ONSITE SEWAGE DISPOSAL SYSTEM

PROPERTY ADDRESS: 14290 Triadelphia Road

From: Williams, Jeffrey
Sent: Monday, February 02, 2015 3:16 PM
To: 'Stephanie Tuite'
Subject: RE: Homewood Interiors BAT (14290 Triadelphia Rd)

SDP-15-010

- PAI NOTES:**
1. ANY CHANGE TO THE LOCATION OR DEPTH TO ANY COMPONENT MUST BE APPROVED BY THE ENGINEER AND THE HOMEWOOD PROPERTIES, LLC.
 2. THE HANNOVER COVER OVER THE BAT PUMP IS REQUIRED.

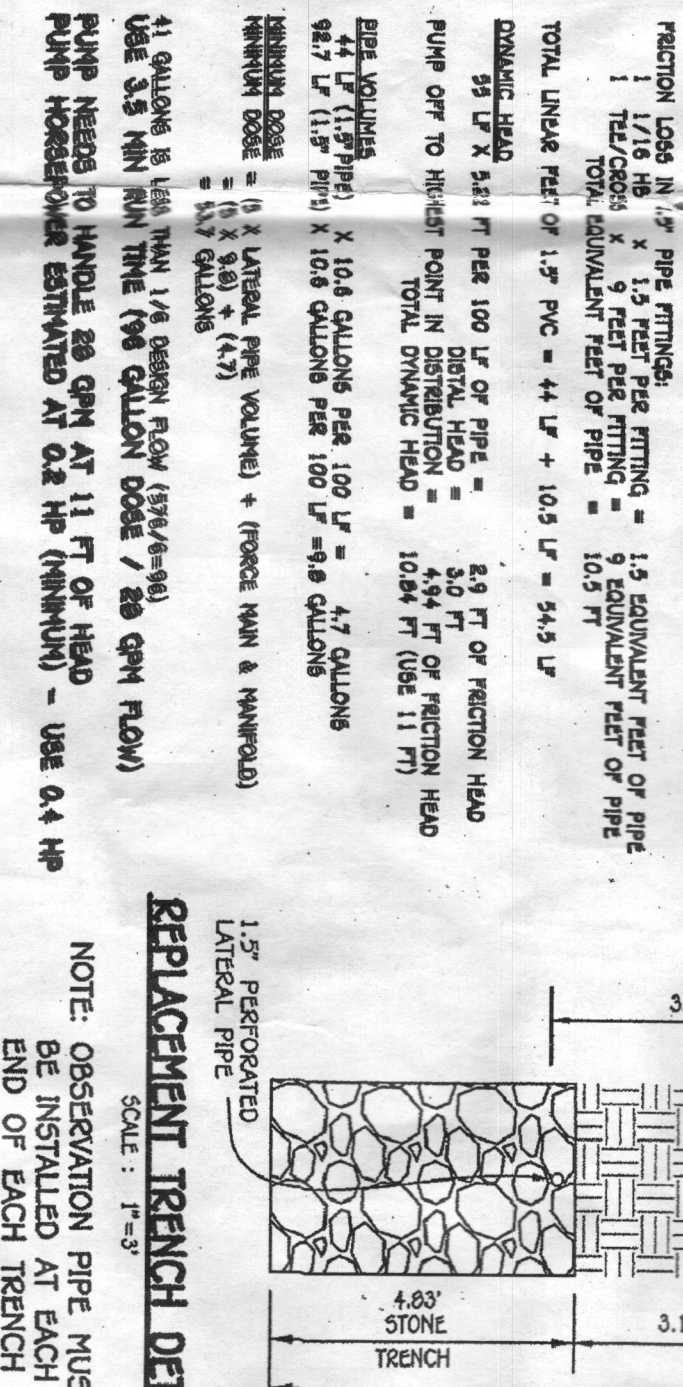
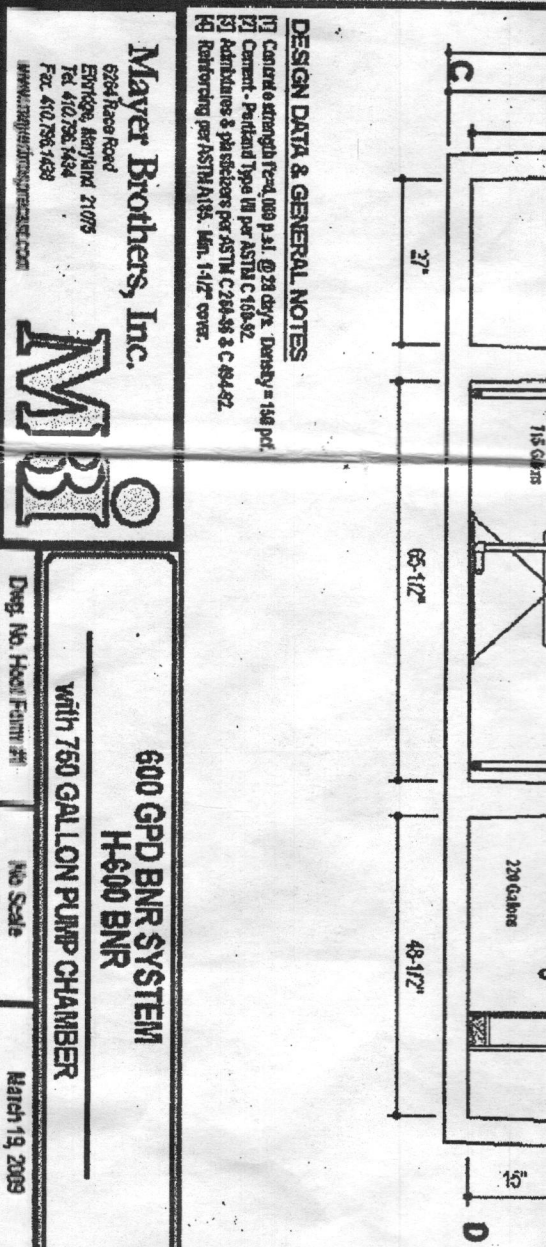
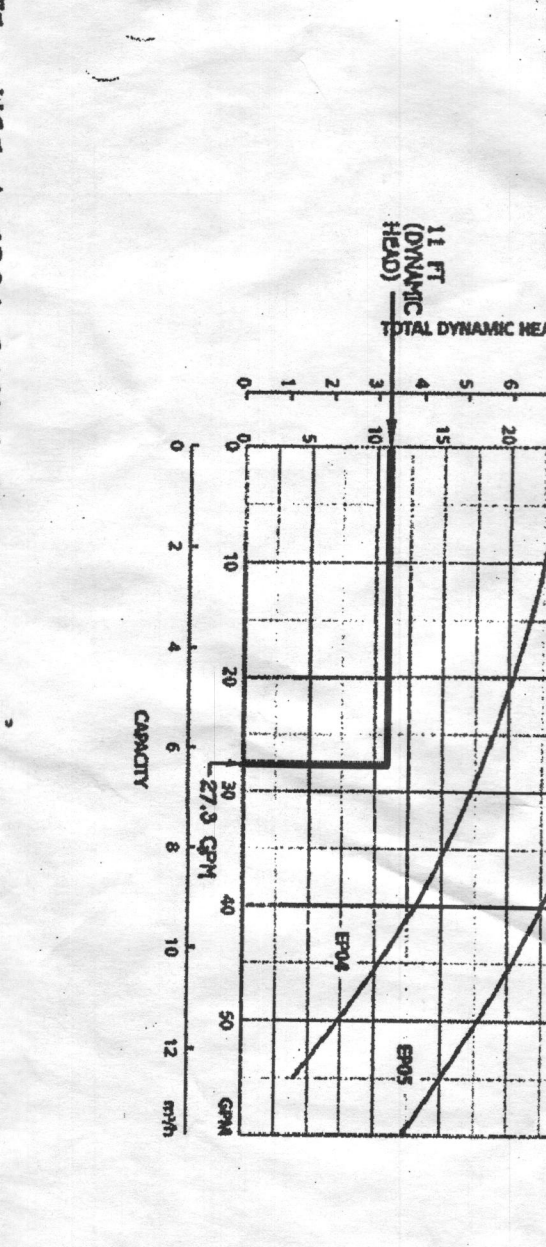
- Static head is elevation difference between pump off float/probe and the highest point in the piping system. The highest point is the invert out of the tank, which you give as 583.5. You give the pump off as 578.56. That puts the static head at 4.94'

- You state friction loss in 2" pipe fittings, but you list all piping at 1.5" diameter.
- You give a volume of 1.25" pipe for the laterals when calculating dose, but elsewhere you show the laterals at 1.5" diameter.

- You show perf spacing in trench 1 at 4.25' with 11 perfs. That gives a lateral length of 44.625, not 48.9 as stated (10 spaces at 4.25' and one half space at 2.125'). This is too short for the trench length at 51'. A spacing of 4.25 could accommodate 12 holes in a 51' trench with a lateral length of 48.875. All other trenches have similar problems.

- An adjustment for the number of perfs will correspond to an increase in the total flow rate for the system.
- The pump run time should be set to correspond to the revised flow rate.

- Show the location of the blower motor and the control panel on the plan.

The perf spacing and lateral length are incorrect based on the info provided.

T1 length 51' with 11 holes should be: 4.636' spacing and 48.68' lateral length
T2 length 51' with 9 holes should be: 5.66' spacing and 48.17' lateral length
T3 length 46' with 11 holes should be: 4.18' spacing and 43.91' lateral length
T4 length 46' with 9 holes should be: 5.11' spacing and 43.445' lateral length

Markup Name	Markup Text	Markup Date	File Name	First Name	Last Name
Jeff Williams	lateral length and perforation spacing is not correct for all trenches based on number of perforations and length of trench provided.	02/20/2015	SDP-15-010 Sheet 5.dwf	Jeff	Williams
Jeff Williams	static head note should state "pump off to highest point in distribution network".	02/20/2015	SDP-15-010 Sheet 5.dwf	Jeff	Williams
Jeff Williams	Add note stating that a BAT plan revision may be necessary to relocate the BAT unit if the proposed location is in conflict with the location of the existing septic tank to be abandoned.	02/20/2015	SDP-15-010 Sheet 5.dwf	Jeff	Williams
Jeff Williams	Include a Health officer signature block on all pages.	02/13/2015	SDP-15-010 Sheet 1.dwf	Jeff	Williams
Jeff Williams	label existing septic tank as to be abandoned	02/13/2015	SDP-15-010 Sheet 2.dwf	Jeff	Williams
